Memorandum

Subject: Additional information—Red River Road Planned Development

Date: November 4, 2011

EXHIBIT G-1

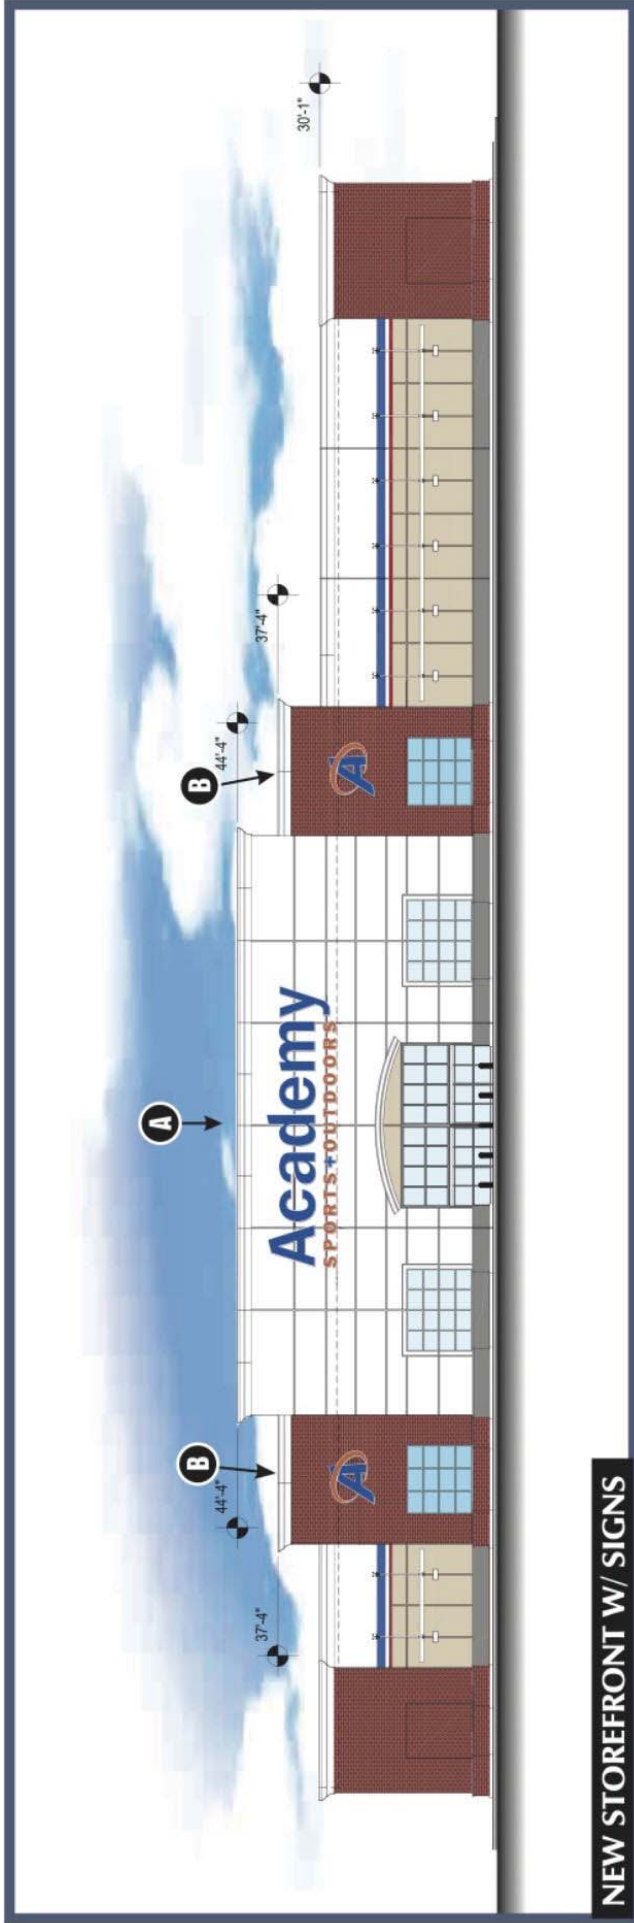
The Greenville storefront sign that faces the interstate is *smaller* than is proposed for the elevation in Rock Hill that faces Dave Lyle Boulevard. The interstate side also does not contain the two "A" logos that are proposed for the Rock Hill location.

EXHIBIT G-2

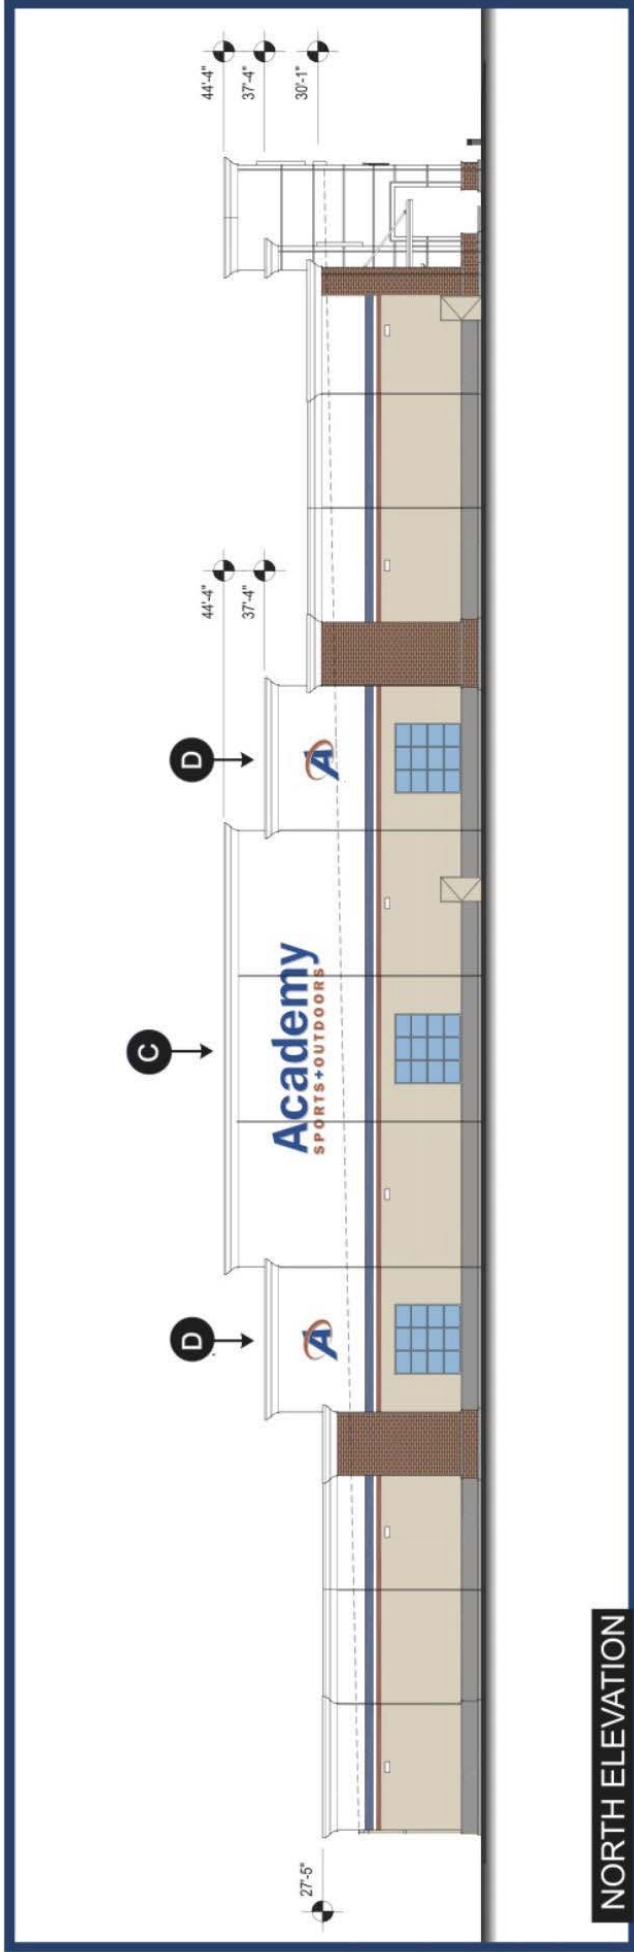
The primary Greenville storefront sign for Academy Sports is *larger* than is proposed for the storefront in Rock Hill. However, the Greenville storefront does not contain the two "A" logos that are being requested at the Rock Hill location.

M-2011-19

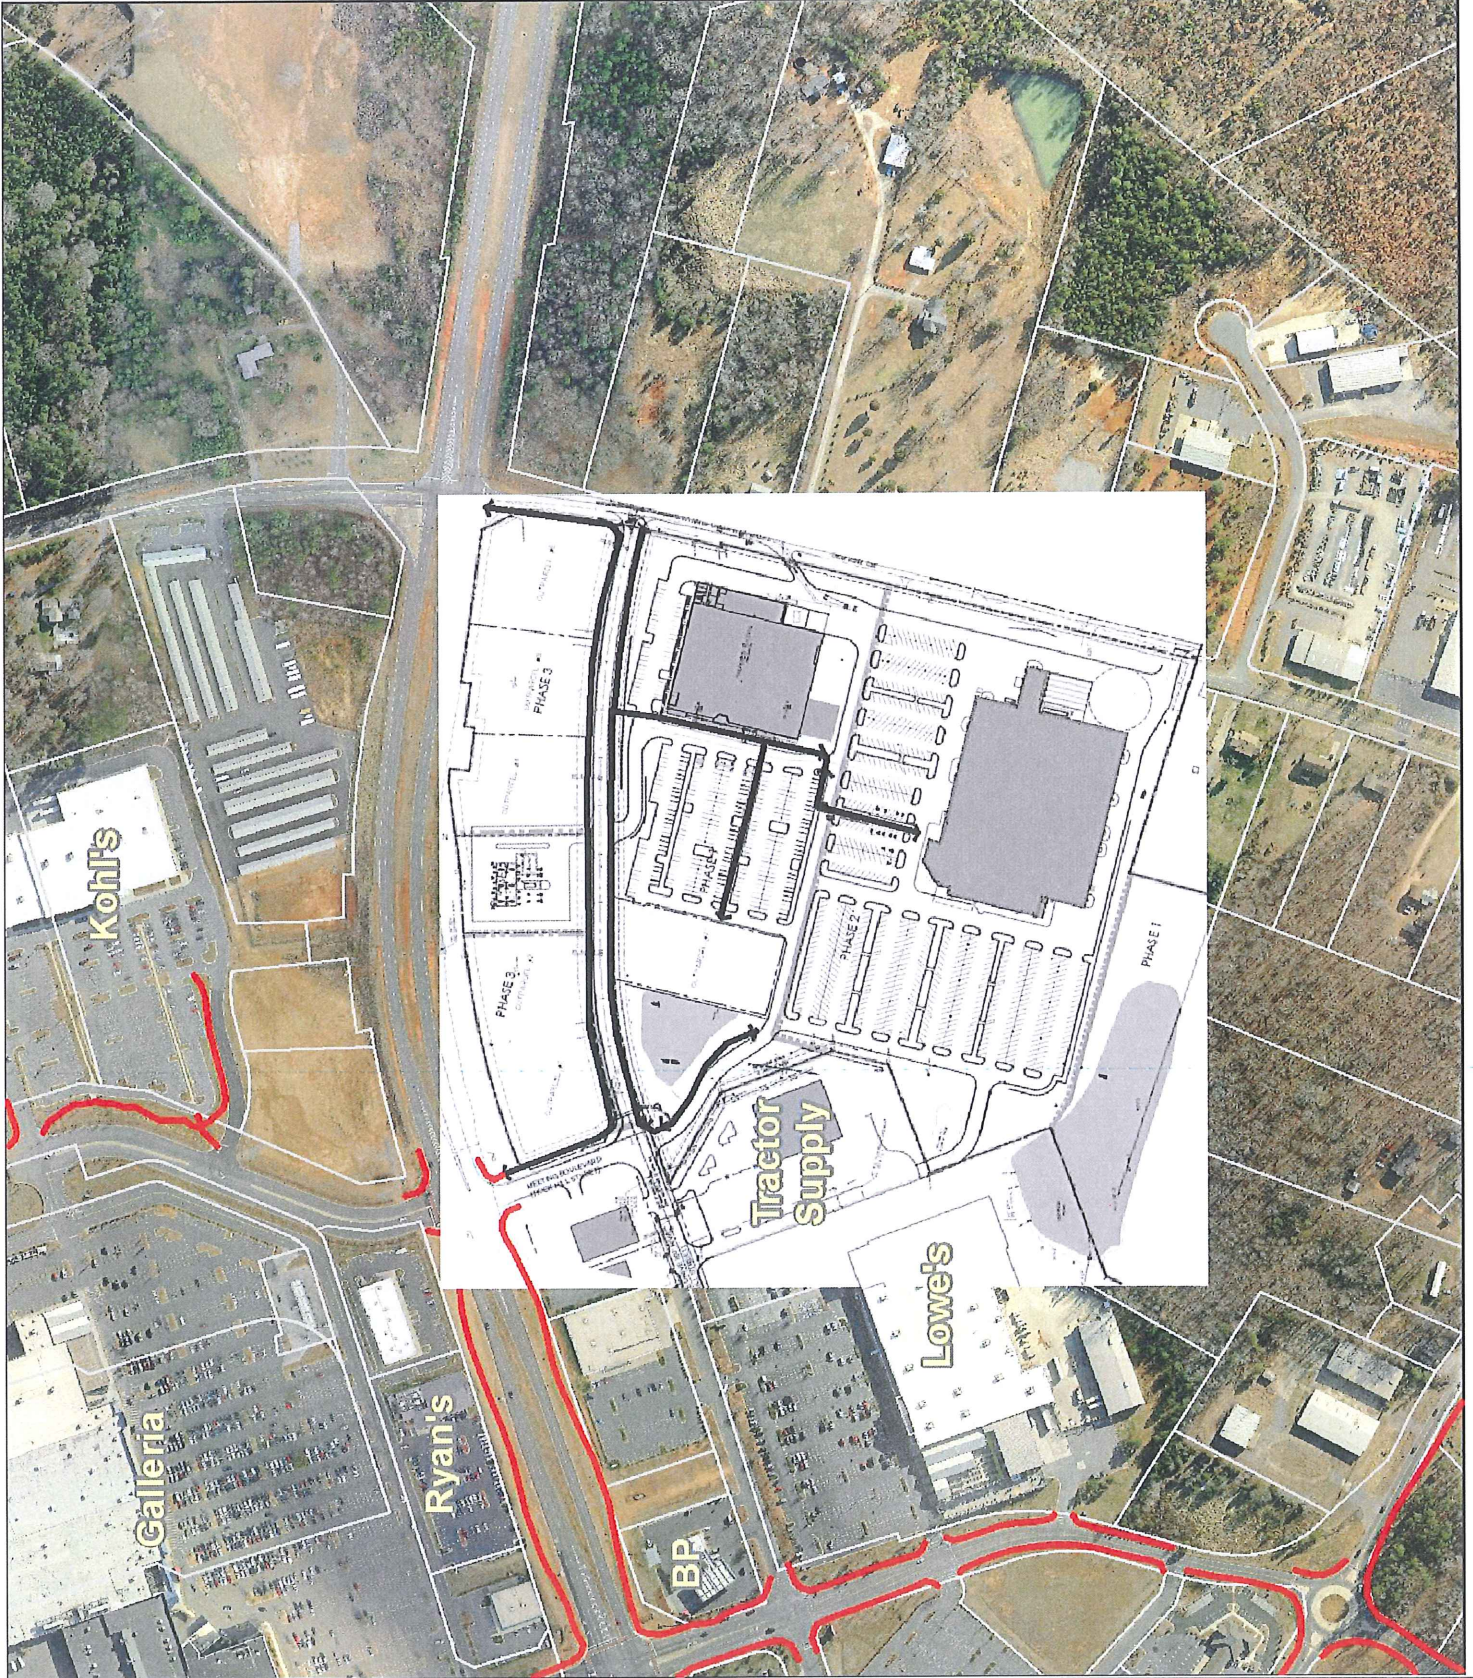
We have attached exhibits showing how the proposed sidewalks and pedestrian pathways of the Red River Road Planned Development connect to the existing sidewalk infrastructure in the area.

The developer proposes to install sidewalks internal to the development along Meeting Boulevard and Cross Pointe extension as well as pedestrian paths between Phases I and II. He does not propose to install sidewalks along Dave Lyle Boulevard nor Red River Road. This means that the existing sidewalk infrastructure would not be continued along the borders of this development if the sidewalks are installed as proposed.
